Public Comment:

F155-07/08

903.6.2 (New)

**FIGURE 2209.5.3.1.1
INDOOR ATTENDED “FAST-FILL” HYDROGEN FUEL-DISPENSING LIMITATIONS**

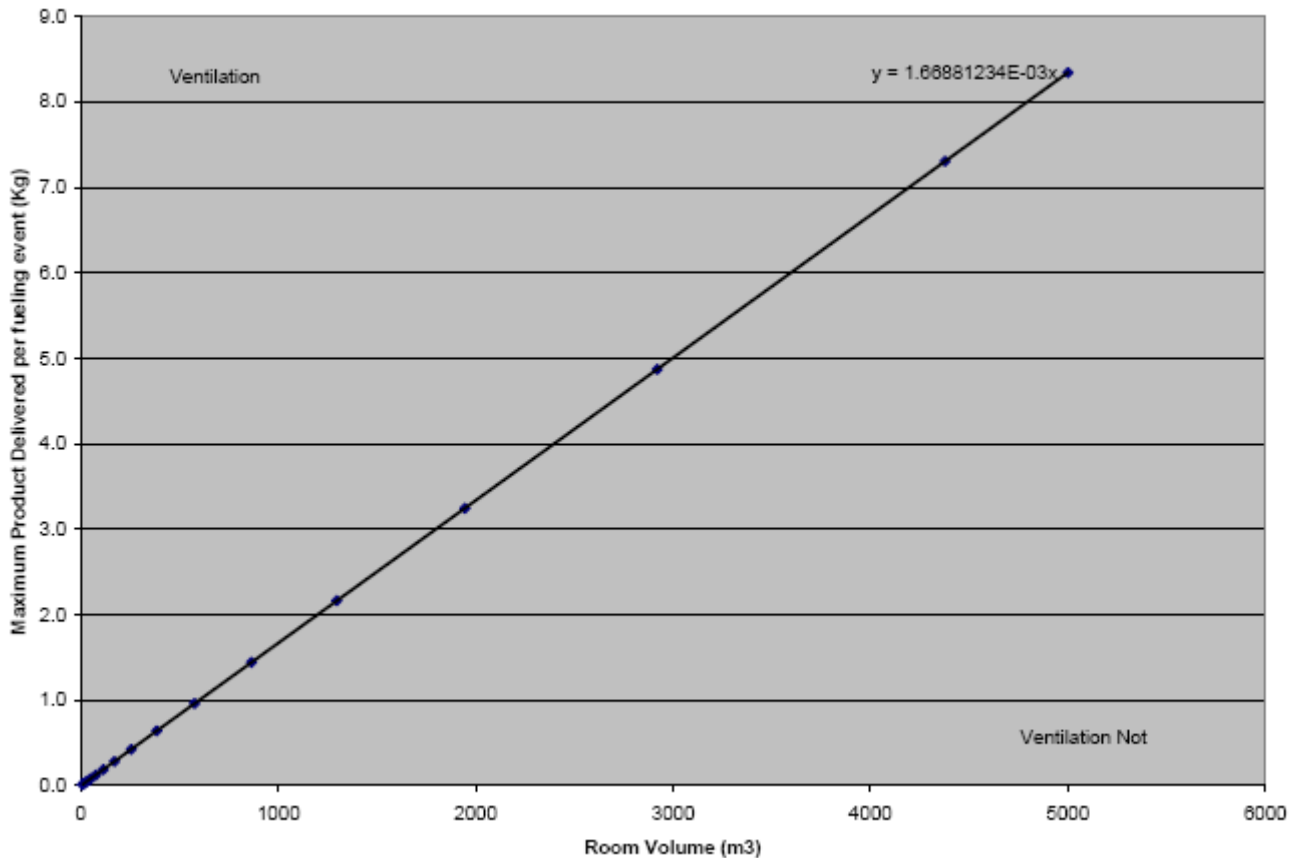
(2209.5.3.1.1 & Figure 2209.5.3.1.1) The proposed change is to establish and clarify two distinct ventilation rates for these operations, a general room ventilation rate, and a dedicated, localized dispensing area ventilation rate. Ventilation rates to be consistent with industry practice by reference to the IFGC.

2209.5.3.1.1 Room ventilation rate. The ventilation rate provided to the room in which the fast-fill hydrogen fuel-dispensing area is located shall be not less than 1 cubic foot per minute per 12 cubic feet (0.00139 m³/s m³) of room volume.

2209.5.3.1.2 Dedicated dispensing area ventilation rate. The ventilation system serving the dispensing area shall be at least 1 cubic foot per minute (0.00047 m³/s) per 12 cubic feet (0.34 m³) of the Class 1, Division 2 cylinder volume (0.00139 m³/s/m³) defined in Section 2209.5.6. The ventilation system serving the dispensing area shall be directed to the outside in accordance with Section 501.3 of the *International Mechanical Code*.

Right before Steady state is being achieved (2 kg/min release) of 1/8 kg inventory (time = 0.42 sec)

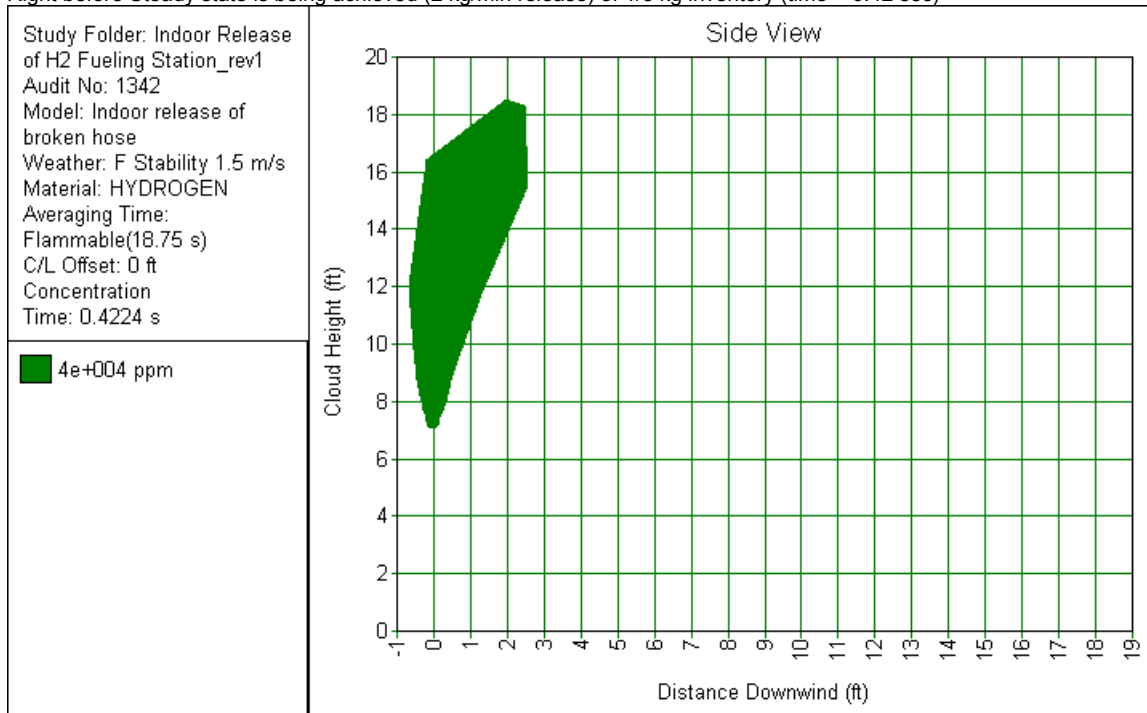
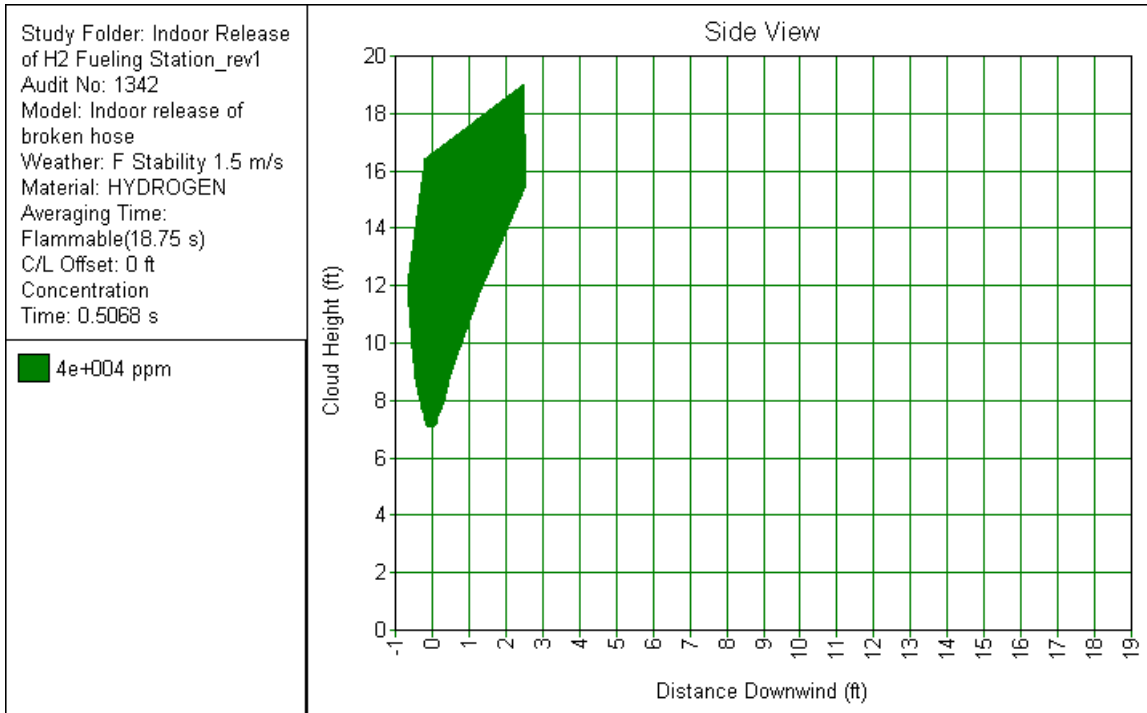
2209.5.3.3.2.2: The minimum ceiling height of the room in which fueling occurs is established at 25 feet. The 25 feet has been determined by modeling a release of hydrogen where steady state conditions were achieved at a height of from 20-22 feet after 2 seconds. The flammable envelope below (shown in green) represents that portion of the cloud within a 4% concentration or greater.

Flammable cloud after steady state is achieved for a release of 2 kg/min. This is the maximum size of the cloud even if the valves isolating the storage fail & the entire contents of the storage are released into the building
